NOTICE OF DRAFTSPERSON'S PATENT DRAWING REVIEW

Applicant: John M. Klein Examiner: Trinh T Nguyen
Serial Number: 09/966,725 Art Unit: 3581
Filing Date: September 28, 2001
Title: NON-LETHAL PROJECTILE AMMUNITION
Our File No.: SAO-104-A-1

REPLY TO OFFICE ACTION (37 CFR 1.111)

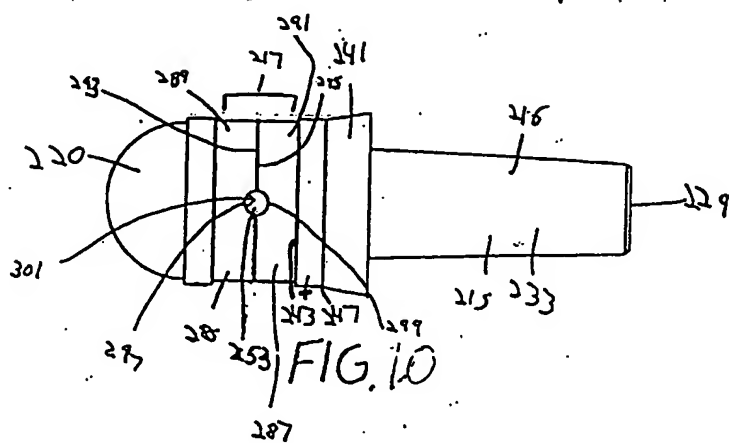
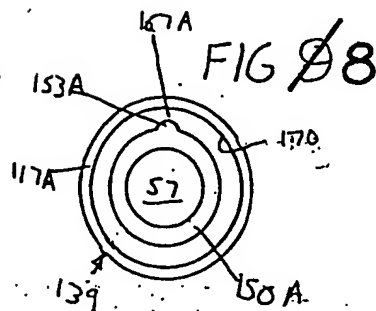
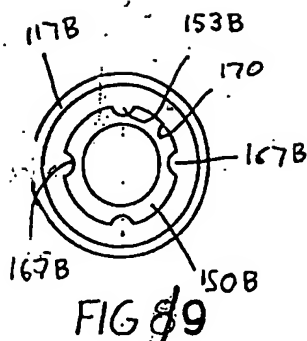
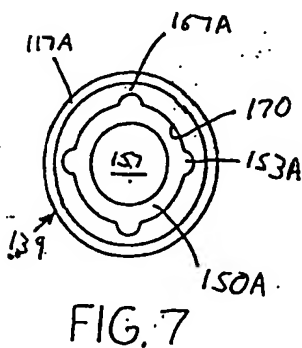
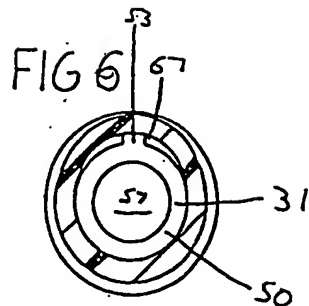
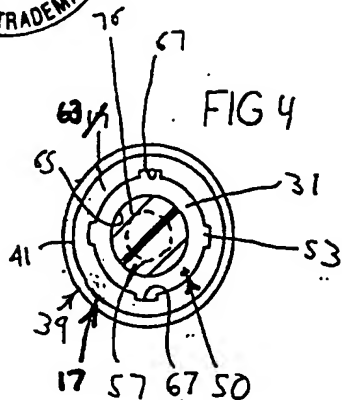
FIG. 1: delete the arrowhead on the leadline for "16", add an arrowhead at the end of the leadline for "17"; and clarify the exterior contour "69" and "71" of the driving band "17".

FIG. 2: change the numbers "16" and "15" to read "15" and "16"; change the number "74" to read "57" for the forward cavity in the leg "50" of the projectile body "11"; add the number "74" and a lead line pointing therefrom to a chamber in the insert member "19"; add the number "21" and a leadline pointing therefrom to the dome shaped wall of the nose "20"; add the number "25 and a leadline pointing therefrom to the interior surface of the nose "20"; delete the number "24" and the leadline therefor; and add the number "23" and a leadline pointing therefrom to a cylindrical annular surface of the interior wall "25" circumjacent to the open end of the nose "20".

FIG. 3: change the numbers "16" and "15" to read "15" and "16"; place an arrowhead at the end of the leadlines from "17" and "19"; shorten the end of the leadline from "54"; and delete the number "74" and the leadline therefore.

FIG. 4: replace the number "17" with "63"; add a number "17" and a leadline pointing therefrom to the drive band; shorten the leadline from "41" to point to the tapered surface; and shorten the leadline pointing to the forward leg "50" and end the leadline with an arrowhead.

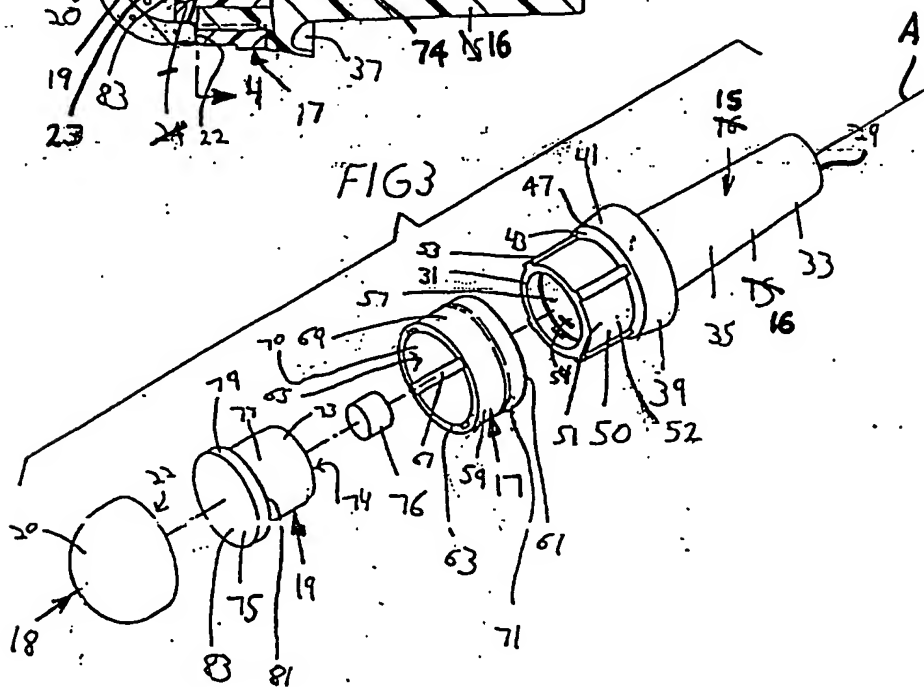
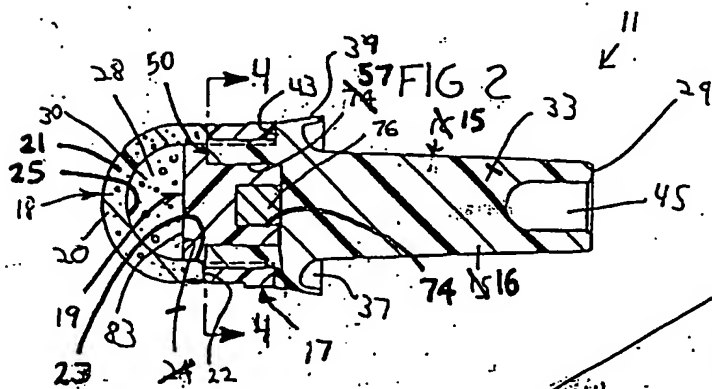
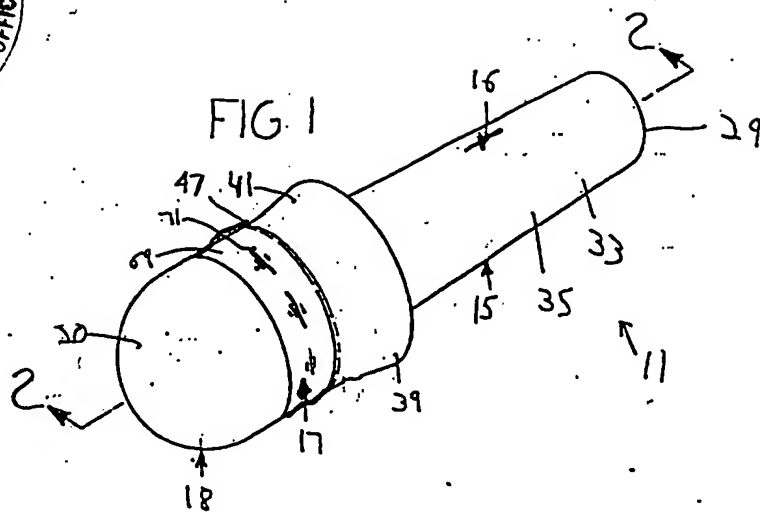
FIG. 8: change the Figure number "8" to read "9".

FIG. 9: change the Figure number "9" to read "8".

FIG. 10: change the leadline from "243" to point the end face.
